# UNITED STATES PATENT AND TRADEMARK OFFICE

10/505,206

Walter Holike

**Office Action Summary**

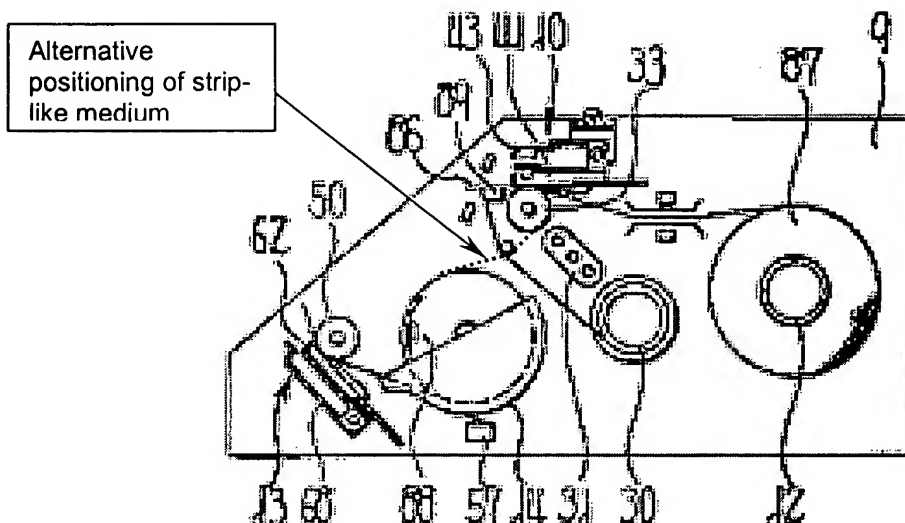
With respect to claim 1, Iida discloses a printer module with a base plate 9,20 which has a mounting area for a first unwinding bearing 12 which holds a first supply roll 87 of a strip-like medium and a mounting for a first printing mechanism which includes a transport roll 33, a rotary drive 38 and a print head 41 opposite the transport roll 33 as shown in Figure 5 of Iida. The base plate 9,20 further has a mounting area for a second unwinding bearing 14, a second supply roll 88 of a strip-like medium and a mounting area for a second printing mechanism which includes a transport roll 50, a rotary drive 58 and a printhead 62 opposite the transport roll 50 as shown in Figure 5 of Iida.

With respect to claim 3, the second unwinding bearing 14 is in a position from which the strip-like medium 88 can be guided optionally either to the first printing mechanism as shown below in the Figure taken from Figure 5 of Iida or to the second mechanism as shown in Figure 5.
